LATIGO TRAILS FILING NO. 10

EL PASO COUNTY, COLORADO PUBLIC UTILITY PLANS

DATE INITIAL ISSUE 9/26/24 1/6/25 RESUBMITTAL

COVER SHEET

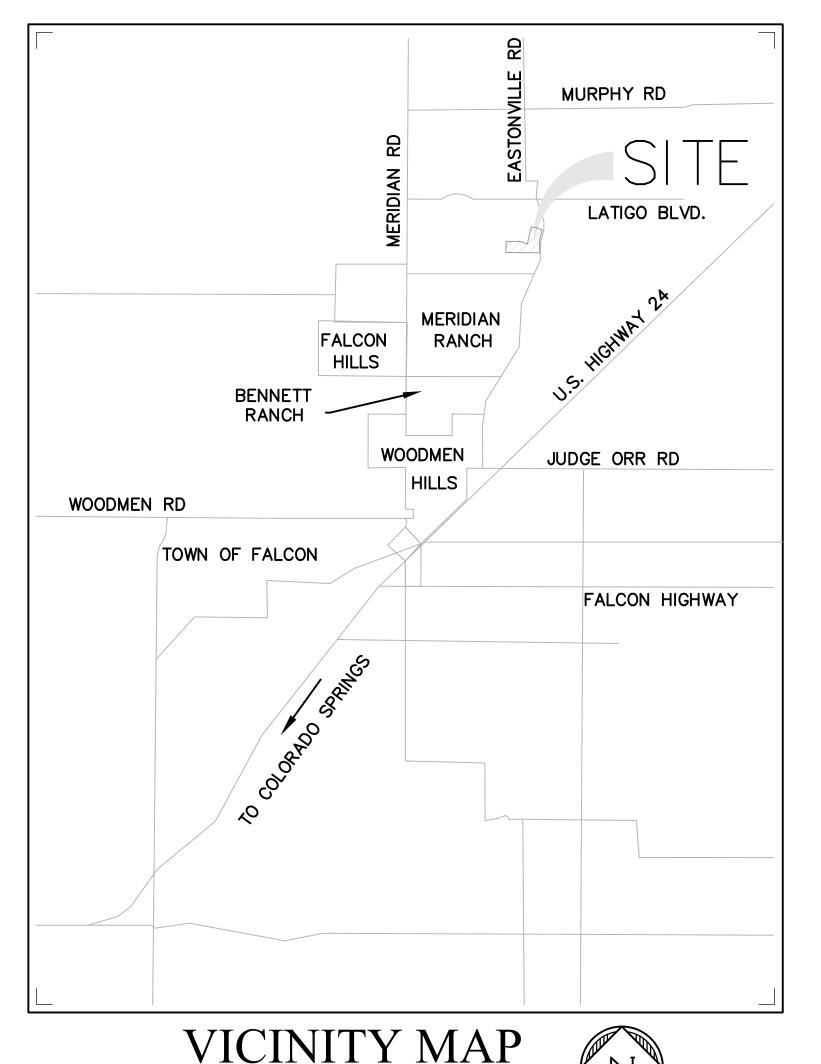
> elete and move this aragraph to be part of the County ignature block
